Refer: 7425-5.1L REV A

SHOALHAVEN STARCHES – MOD 9 & 21 – PACKING PLANT DESIGN NOISE VERIFICATION

Day Design Pty Ltd has been engaged to prepare a Design Noise Verification Report for modification approval MP 06_0228 issued by the Minister for Planning for the Packing Plant and container storage yard to be constructed at Lot DP 1121337 and Lot 2 DP 538289 Bolong Road, Bombaderry, NSW (Modification 9) and Packing Plant Alterations and Other Works (Modification 21).

Appendix D – Packing Plant Ventilation Fans – General Arrangement

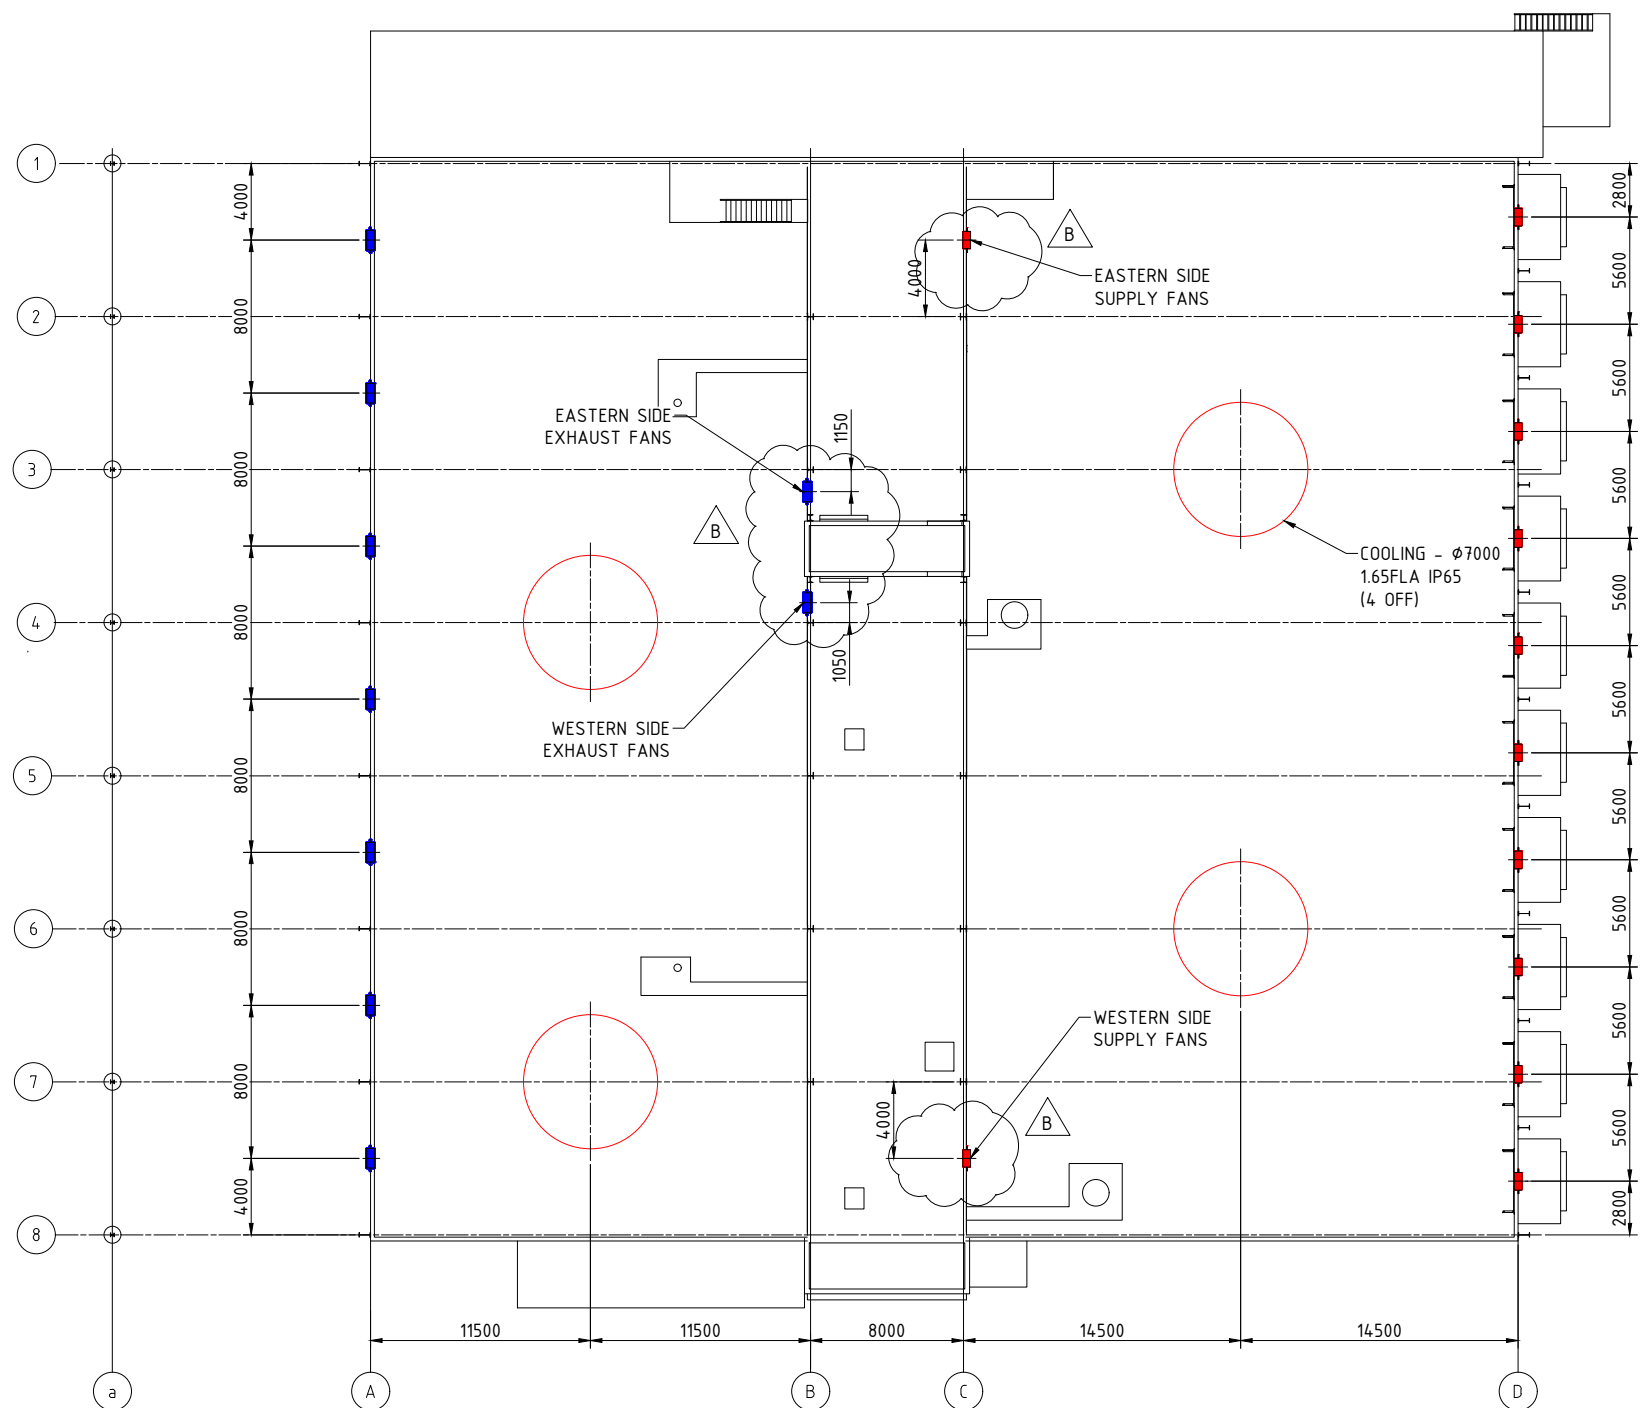
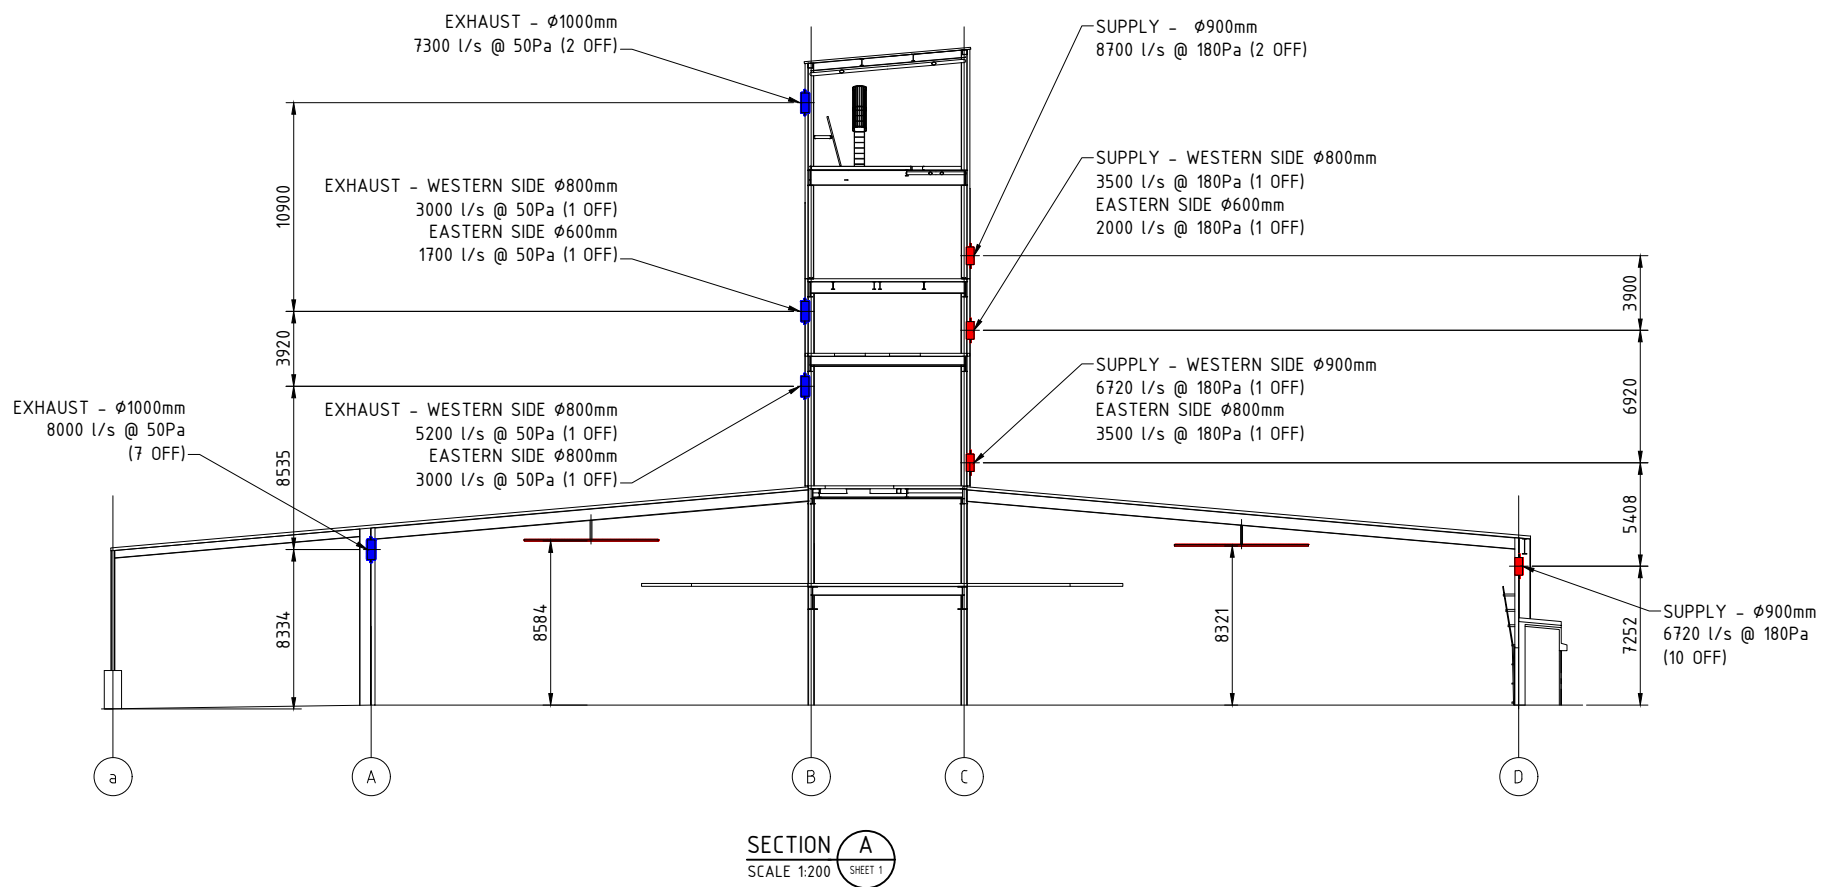
We have reviewed preliminary mechanical drawings titled 'Revision B - Ventilation Fans General Arrangement', dated 20 September 2021, prepared by Foxground Engineering, which indicate the location and quantity of each ventilation fan to serve the plant. Attached as Appendix D.

We have also reviewed the fan specifications for each fan as supplied by Fanquip, received via email on 31 March 2023. A schedule of ventilation fans, as supplied by Fanquip, is shown in Table 2. It is noted that noise levels of some fans include inline silencers fitted. Sound power levels for these fans include attenuation provided by inline silencers, as supplied by Fanquip.

We are advised by Fanquip that acoustic louvres will be fitted to the external façade to attenuate noise from supply and exhaust fans which do not have inline silencers fitted. Attenuation values for Fanquip louvres are shown in Table 3.

The current design of the north awning area will include 7 exhaust fans which will be enclosed below the awning roof, fully enclosed within the north awning area. These exhaust fans will operate 24 hours a day.

The current design of the main packing plant building will include 10 supply fans installed within the southwest facade. These supply fans will operate 24 hours a day.

The current design of the packing plant penthouse includes four ventilation fans serving each level of the penthouse installed within the northeast and southwest walls for a total of 12 fans. These exhaust fans will operate 24 hours a day.

- Supply/exhaust fans without inline silencers should have Fanquip Model 300 acoustic louvres installed on the intake or discharge of each fan, or an equivalent louvre that achieves or exceeds the insertion loss values specified for this model of acoustic louvre.
